CODE CHANGES RESOURCE COLLECTION: 2009 IPC®

APPROVED CODE CHANGES RESULTING IN THE 2009 IPC®

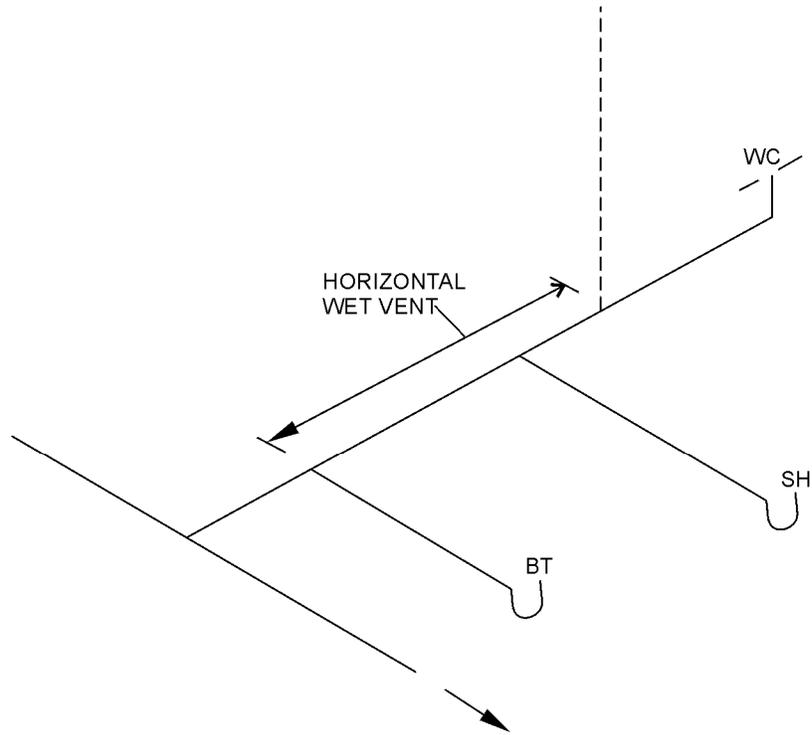
~~**P3108.2 Vent connection.** The dry-vent connection to the wet vent shall be an individual vent or common vent to the lavatory, bidet, shower or bathtub. In vertical wet-vent systems, the most upstream fixture drain connection shall be a dry-vented fixture drain connection. In horizontal wet-vent systems, not more than one wet-vented fixture drain shall discharge upstream of the dry-vented fixture drain connection.~~

~~**P3108.2 Dry vent connection.** The required dry-vent connection for wet-vented systems shall comply with Sections P3108.2.1 and P3108.2.2~~

P3108.2.1 Horizontal wet vent. The dry-vent connection for a horizontal wet-vent system shall be an individual vent or a common vent for any bathroom group fixture, except an emergency floor drain. Where the dry vent connects to a water closet fixture drain, the drain shall connect horizontally to the horizontal wet vent system. Not more than one wet-vented fixture drain shall discharge upstream of the dry-vented fixture drain connection.

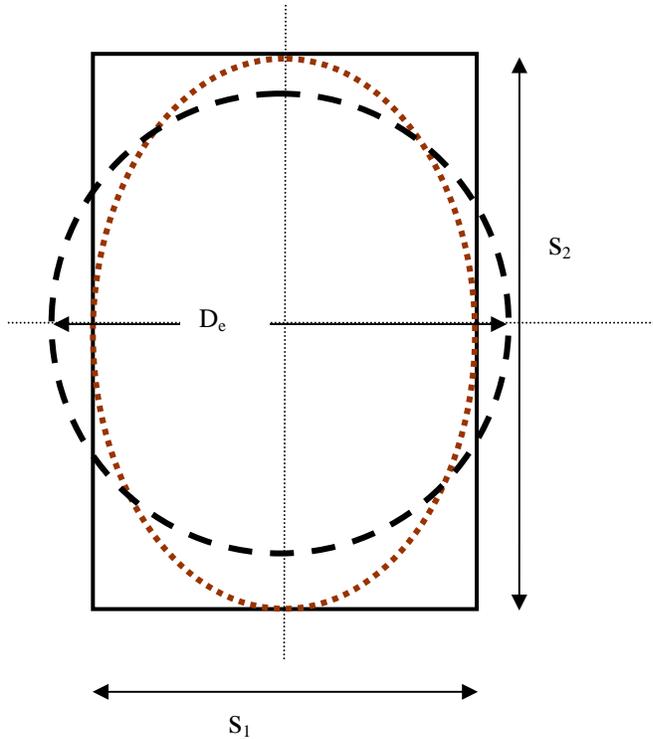
Reason: The purpose of this change is to provide design values for rectangular leaders, which are already commonplace in commercial construction. The current code provisions only provide design values for circular storm leaders and conductors. While circular interior conductors are commonplace, exterior leaders are almost always fabricated from sheet metal coils into rectangular profiles. The current code allows for the use of other geometric profiles, but it restricts the allowable flow to the area of an inscribed circle. This provision is overly conservative and does not appear to be supported by hydraulic theory. Furthermore, rectangular shapes are severely penalized because the inscribed circle does not account for the additional flow capacity of a rectangular profile.

Table 1106.2 of the 2006 International Plumbing Code is based on empirical investigations of circular leaders. The table provides, for the purposes of design, the relationship between roof area, rainfall rates and the required leader diameter. The Metal Building Manufacturers Association has performed an engineering study to determine a more reasonable rationale for determining the flow capacity of rectangular vertical leaders. This proposal uses simple geometry to conservatively equate the allowable horizontally projected roof area when utilizing rectangular leaders to the allowable areas in Table 1106.2. Applied in the practical range of rectangular leader cross-section geometry, this method would continue to be somewhat conservative without unduly penalizing the capacity of rectangular leaders. One way of looking at this in terms of equivalent flow capacity is to imagine forming a circular leader into an ellipse while maintaining its circumference and inscribing this ellipse such that it intersects the midpoint of all four sides of the rectangular leader.

The following is the algebraic derivation of the equivalent circular diameter, D_e . The rectangular leader, inscribed ellipse, and the "equivalent" circular diameter are shown in the attached figure. The values in proposed Table 1106.2.2 are based on: (1) Determining the area of an inscribed elliptical area based on the S_1 (Length) and S_2 (Width) dimensions of the rectangular leader, (2) using the area of this inscribed ellipse to determine the diameter of an equivalent circle (D_e) and assigning either the published value or an interpolated value from renumbered Table 1106.2.1 for the equivalent diameter circle to the rectangular leader to determine the maximum horizontal projected roof area that can be drained using the rectangular leader for each rainfall rate.
